## ***Interactive comment on “CAMELS-BR: Hydrometeorological time series and landscape attributes for 897 catchments in Brazil” by Vinícius B. P. Chagas et al.***

Reply to comments by Reviewer #1, Wouter Knoben.

**Fig. 1.** Figure R1. Example of attributes with symbols scaling with catchment size in the previous manuscript, in the revised manuscript, and with symbols not scaling with catchment size.

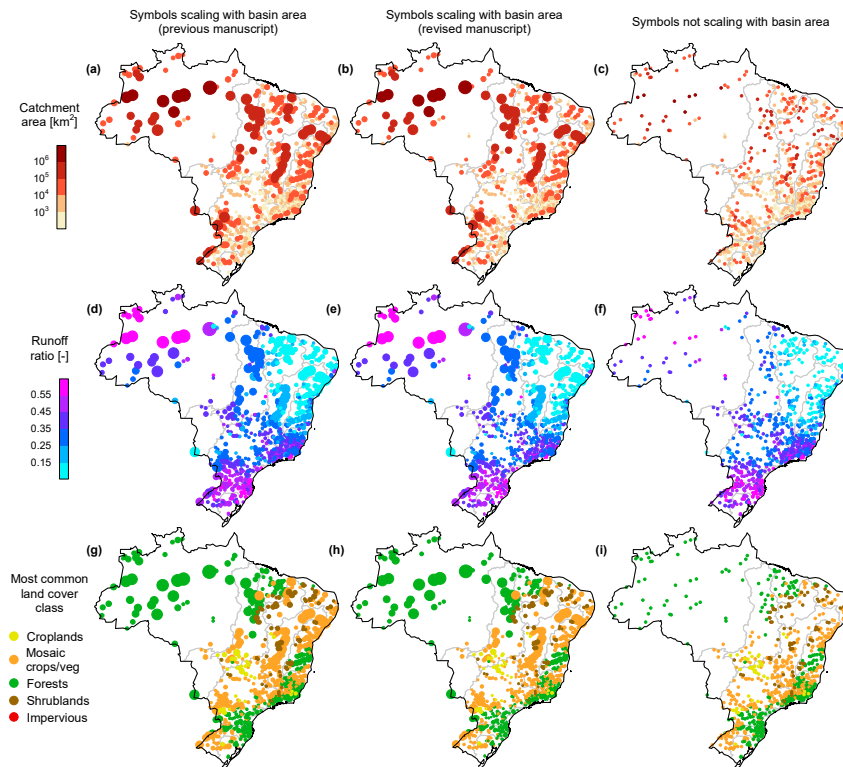
Comment #19: Figures: it is a bit difficult to make out any details in the figure in the south-east region, where gauge density is high. It might be worthwhile to not scale the data points according to catchment size (although keeping this scaling in Figure 1 is quite informative) in the data plots.

Reply: We have tried your suggestion and it seems that not scaling the symbols with catchment area did not solve this problem. It seems that it also hinders the visualization in low gauge density regions (see Fig R1c, f, i). Although the southeastern region has a high gauge density, those are usually the smallest catchments in the country (Fig R1a). We believe that scaling the symbols with catchment size facilitates the data visualization, particularly in the southeast.

We tried to improve the visualization by decreasing the size of all symbols but keeping them scaling with catchment size. In this way, it enhanced the visualization of high gauge density regions without hindering the visualization of low gauge density regions (Fig R1a-b, d-e, g-h). The following Figures were modified: Fig 1, 4, 5, 6, 7, 8, 9, and 10.

**Fig. 2.** Figure R2: Gauges selected using three different criteria.

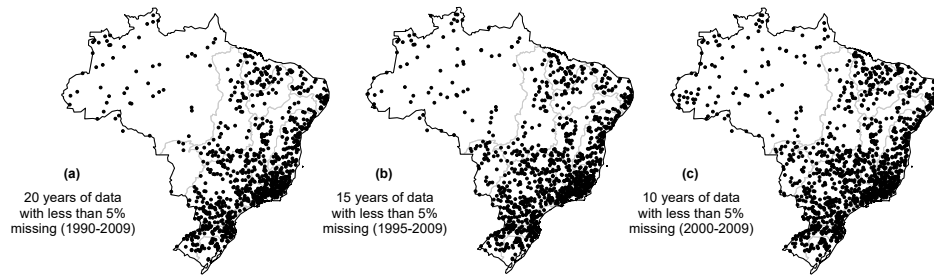
Comment #31: Is there a possibility to improve the density of watersheds in the western part of the country ? I understand that the spatial density of observations/stations is lower and that these stations might have been excluded for some reasons ? But, hypotheses of exclusion might be relaxed in regions where station density is lower, in order to have a more homogeneous spatial coverage of the county ?

Reply: Even if we use a more relaxed selection criterion, the gauge density increase would be noticeable only in a small portion of the western part of the country (see Fig. R2). If we consider all basins with 10 years of data and less than 5% missing (from

2000-2009), only the upper Paraguay basin would have increased gauge density (Fig. R2c). Changes in other regions, such as the Amazon, Tocantins-Araguaia, and lower Paraguay, would barely be noticeable.

Changing to a more relaxed selection criterion would remove the consistency among CAMELS-BR and the other CAMELS datasets. Additionally, reducing the coverage period would lead to substantial increases in the uncertainty of climatic and hydrological indices. We are aware that the users of the dataset might want to consider those additional catchments in further research, which is why we have included streamflow data from all 3679 catchments in Brazil in the manuscript.
